Tech Bulletin: DeltaForce with Dawn GFX Compatibility

August 21, 2014

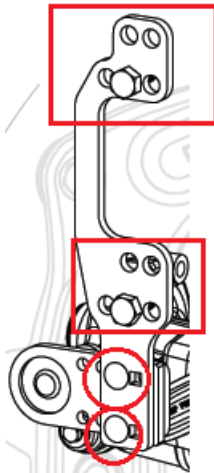
The Problem: Dawn GFX row cleaners are being installed on many new John Deere planters by the dealership. The installation method used by the Deere dealer allows the DeltaForce cylinder to contact and damage the cast cover for the hydraulic attachment on the GFX cylinder.

The Solution: In order to reduce interference and allow compatibility between DeltaForce and the newer GFX systems, it will be necessary to:

- 1) Reorient the bracket.
- 2) Set the row cleaner to the setting closest to the frame (hitch).
- 3) Move the yoke up.

JD installation from Dealer

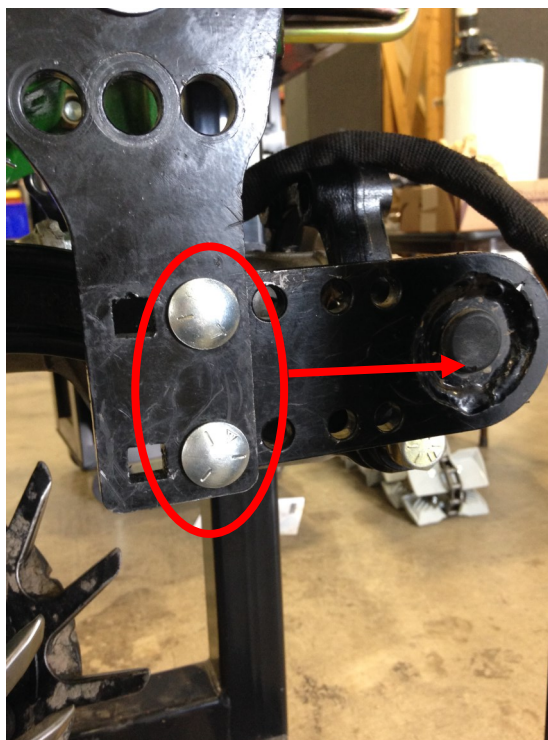
This bracket orientation allows Dawn GFX Row Cleaners to be compatible with DeltaForce with no interference.

Move Row Cleaner all the way forward.

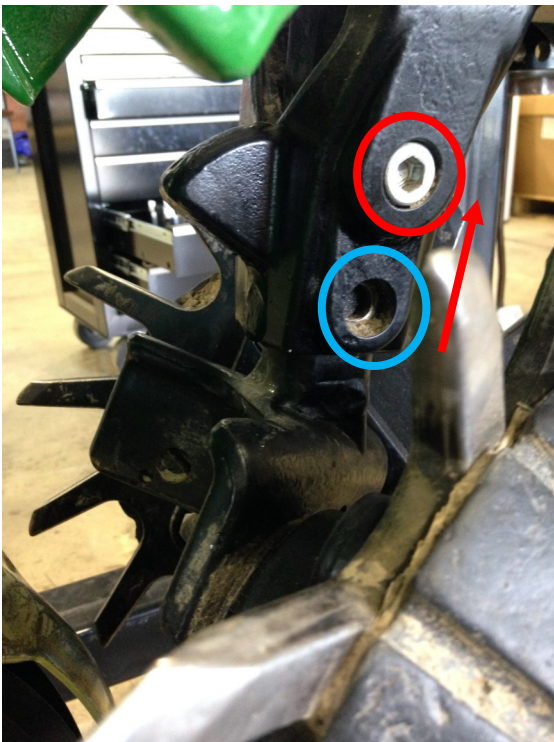
Move the yoke up. The bottom hole illustrated by the blue circle is no longer used.

Once the row cleaner is repositioned, Interference between DeltaForce and the GFX row cleaner is eliminated.
